# Technical Data Sheet

## Bennington 8350 Side Door Latch Upgrade Kit #93-73508

**Publish Date: 3/27/2006**

**Figure 1: Latch Upgrade Components**

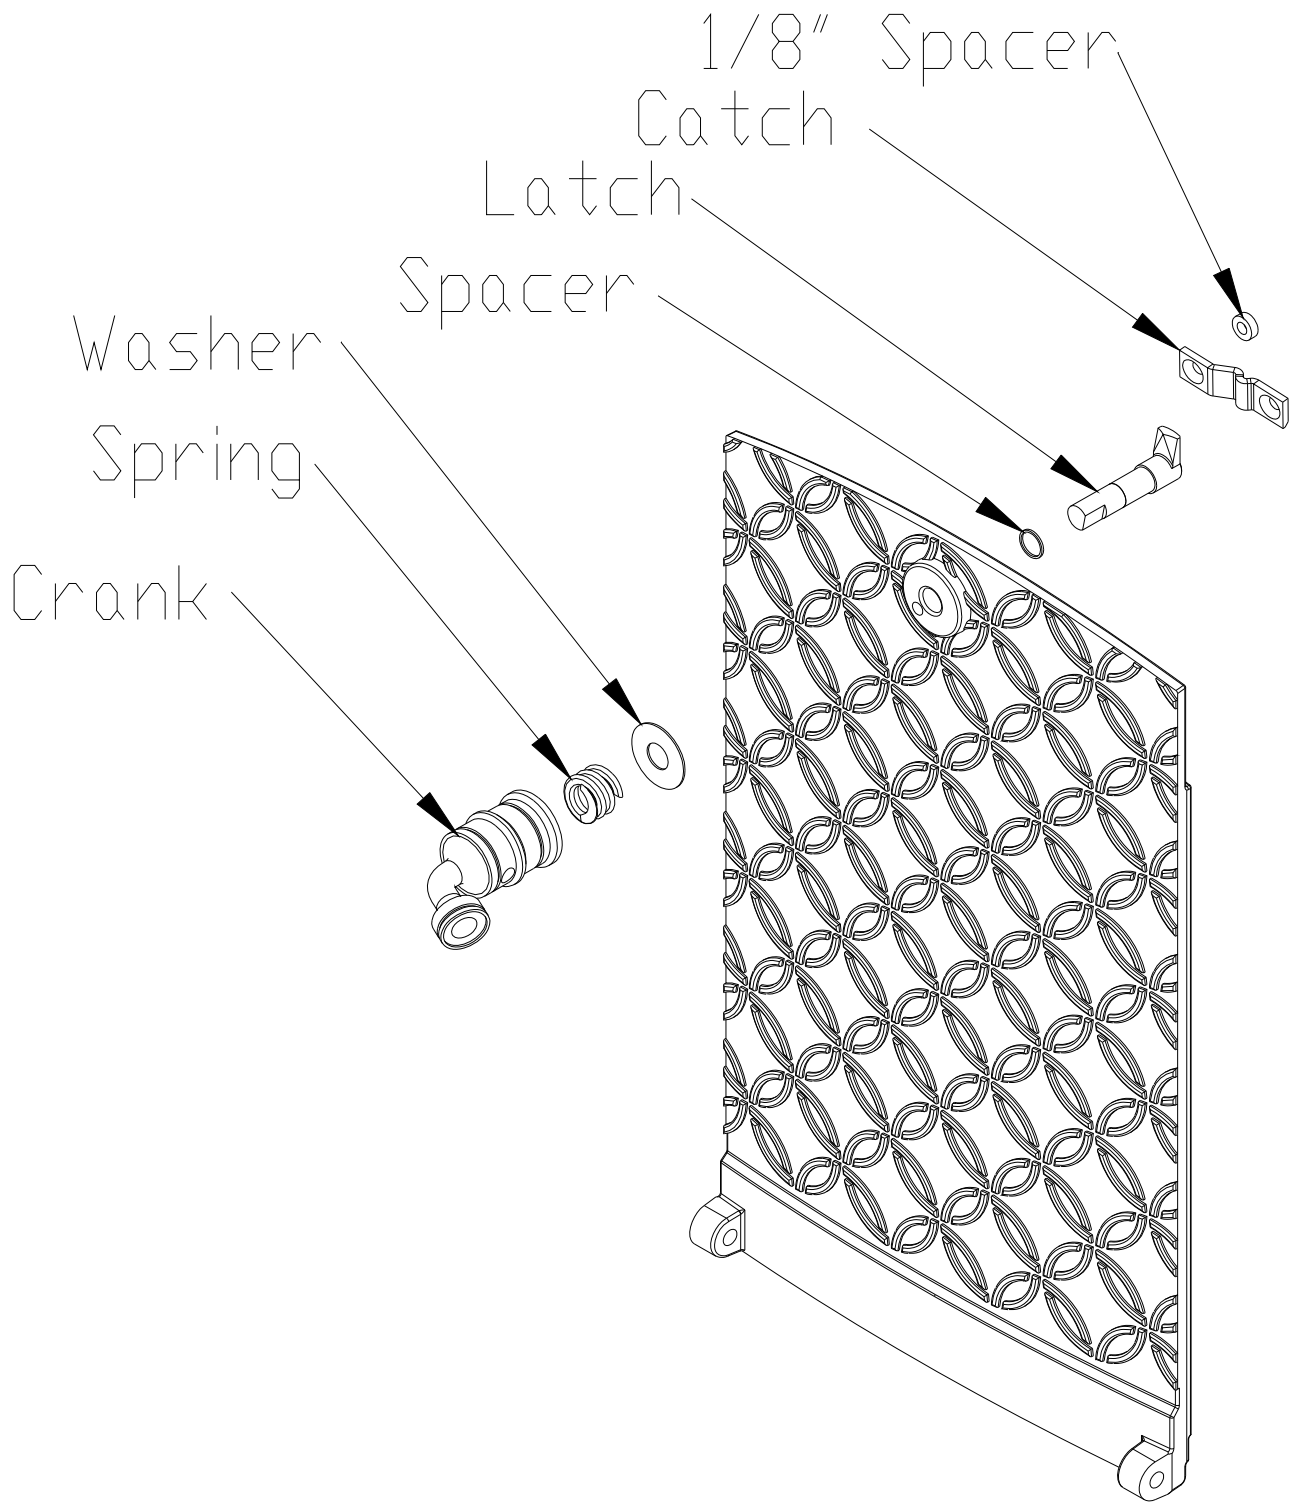
- 1) Remove and discard the side door latch assembly by loosening the two setscrews.
- 2) On models built before September 2005 (serial numbers below 3115), remove and discard the side door catch only by removing the two Phillips head screws.

- 3) Install the new catch using the screws removed in step #2 inserting the 1/8" spacer behind the left side of the catch (as shown on sheet 2).
- 4) Install the new latch assembly as shown on sheet 2. Start out with one brass spacer ring on the latch shaft inside of the door. With the latch shaft extending through the door, place the washer and coil spring on the latch shaft on the outer side of the door. The chrome crank can now be threaded onto the latch. Turn the crank until there is approximately 1/8" between the crank and the washer.

- 5) Align the setscrew hole in the crank with the flat on the latch shaft and insert and tighten the setscrew with the 5/32 hex wrench.
- 6) Check door seals using the "dollar bill test." Shut the door on a dollar bill. If the bill pulls out without any resistance, then your stove's door isn't sealed properly. Spacers can be added or removed to adjust pressure on the gasket.
